DOCUMENT - 2026-264T

**Interior and Exterior Renovations at Peel Regional Police 12 Division, 4600
Dixie Road, Mississauga
ADDENDUM NO. 3**

Referring to the above Document 2026-264T - Interior and Exterior Renovations at Peel Regional Police 12 Division, 4600 Dixie Road, Mississauga, please note the following:

LIGHT FIXTURE SCHEDULE

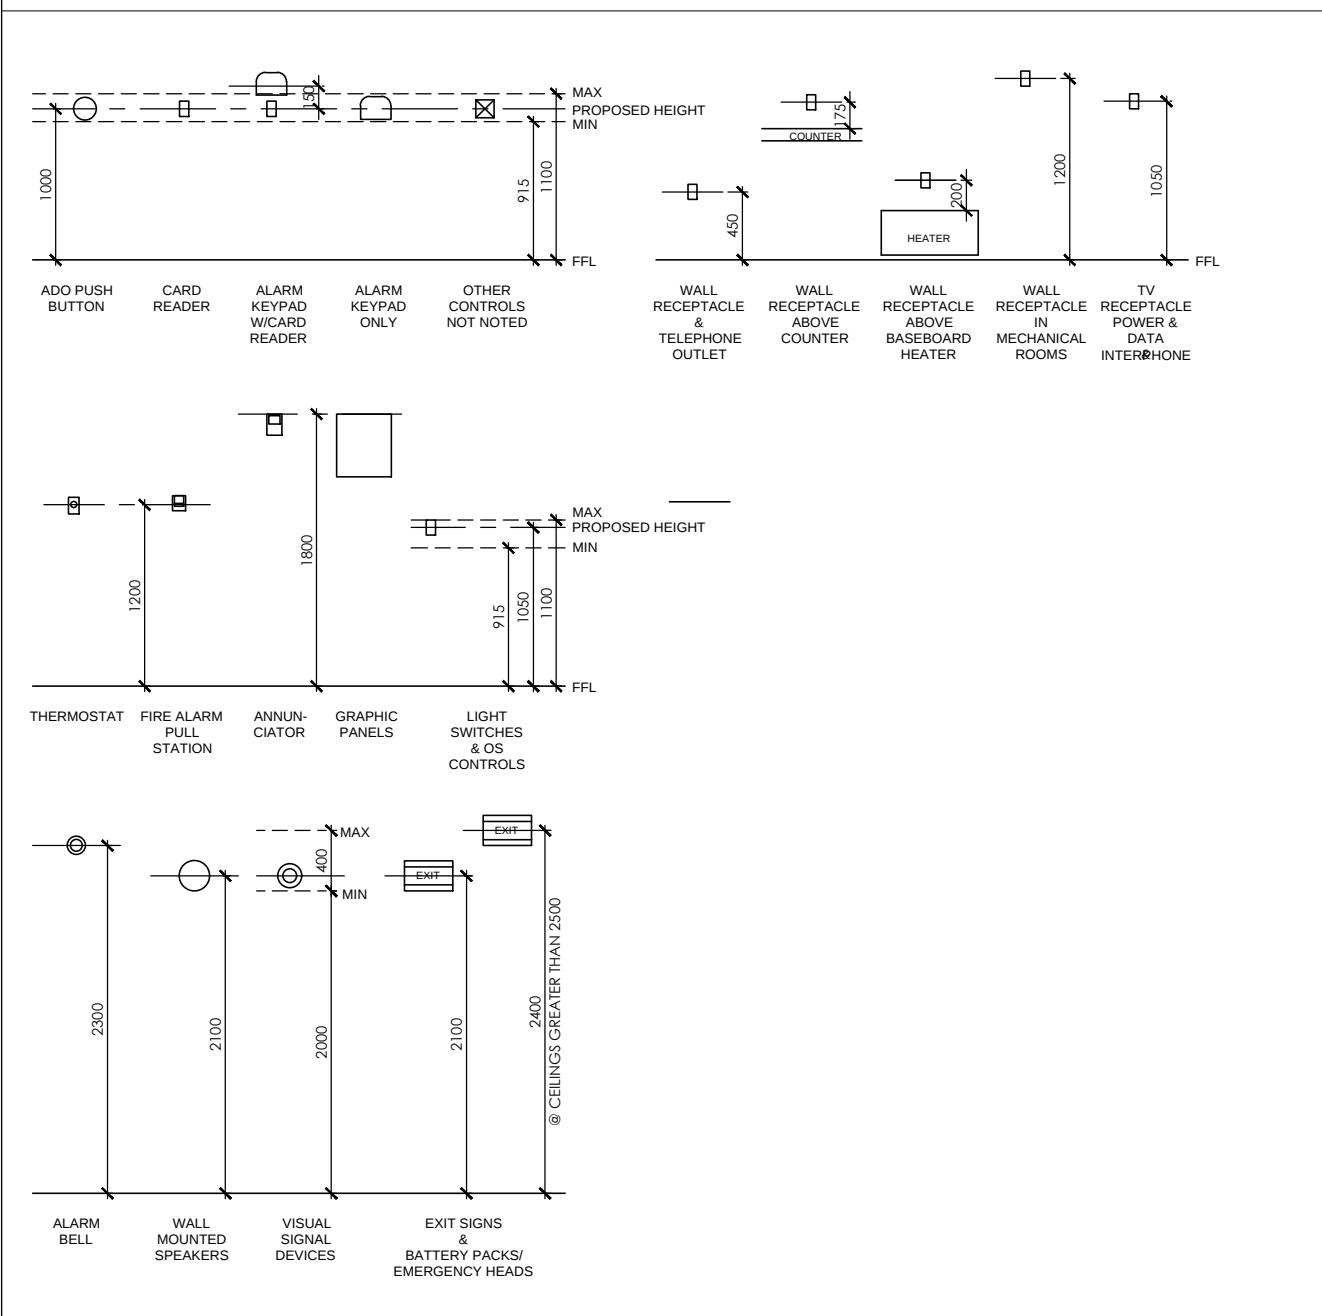
There is also missing information for light L6 ON the lighting schedule

L6 fixture: Lithonia Lighting, FMVCSLS Vanity LED, Model# FMVCSLS 24IN
MVOLT 30K35K40K 90CRI BN M6. Refer to the attached revised Lighting
Schedule in A800 Revision 1, the previous one had the item tags shifted down.
